## PFA AIRWORTHINESS INFORMATION

### EUROPA CLASSIC AND EUROPA XS TAILPLANE FLUTTER AVOIDANCE AND INTEGRITY OF TAILPLANE ATTACHMENT

**Applicability:** All Europa Classic and Europa XS aircraft.

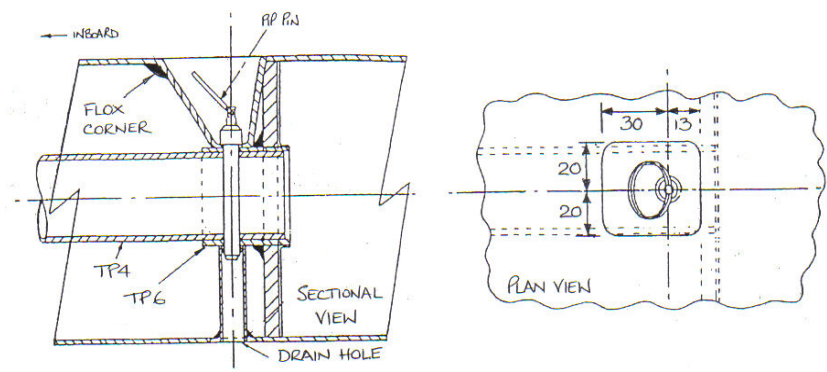
1. Check for relative movement between the tailplane mass balance arm and the tailplane torque tube TP04. PFA's Europa Safety Bulletin PFA 247/FSB-002 dated 18.04.00 refers. Play of this sort is most likely due to worn holes for the TP14 interference fit pins in the TP09 torque tube drive horn assembly or at the arm attachment to the TP09 horn. Due to the vital role of the mass balance arm in preventing tailplane flutter, the play between the mass balance arm and either tailplane half must not exceed 1/2" measured at the tailplane trailing edge. This must be measured by having an assistant hold the P1 control column full back so that the mass balance arm is pressed against the up stop, and measuring the free play at each tailplane trailing edge under moderate up/down hand pressure. In cases of free play exceeding 1/2", Europa mod 62 provides a repair scheme for eliminating play in mass balance arm attachments. See diagram.

2. Check correct mass balancing of tailplane. The mass balancing may not have been correctly carried out at build, alternatively any rework or repainting of the tailplane carried out since may have upset the balance. The tailplane balance may be checked with the tailplane halves fitted to the fuselage in the normal manner. Check that the control columns are not obstructed by the harness or other cockpit items. Then, standing at one tailplane tip, check that the tailplane does not tend to balance either trailing edge up or trailing edge down, but remains in any position it is placed in. Then check that deflections of the tailplane in the trailing edge up and trailing edge down direction from the neutral position require equal forces ie there is no bias in either direction. If adjustment of the mass balance weight is needed to achieve this condition, refer to build manual.
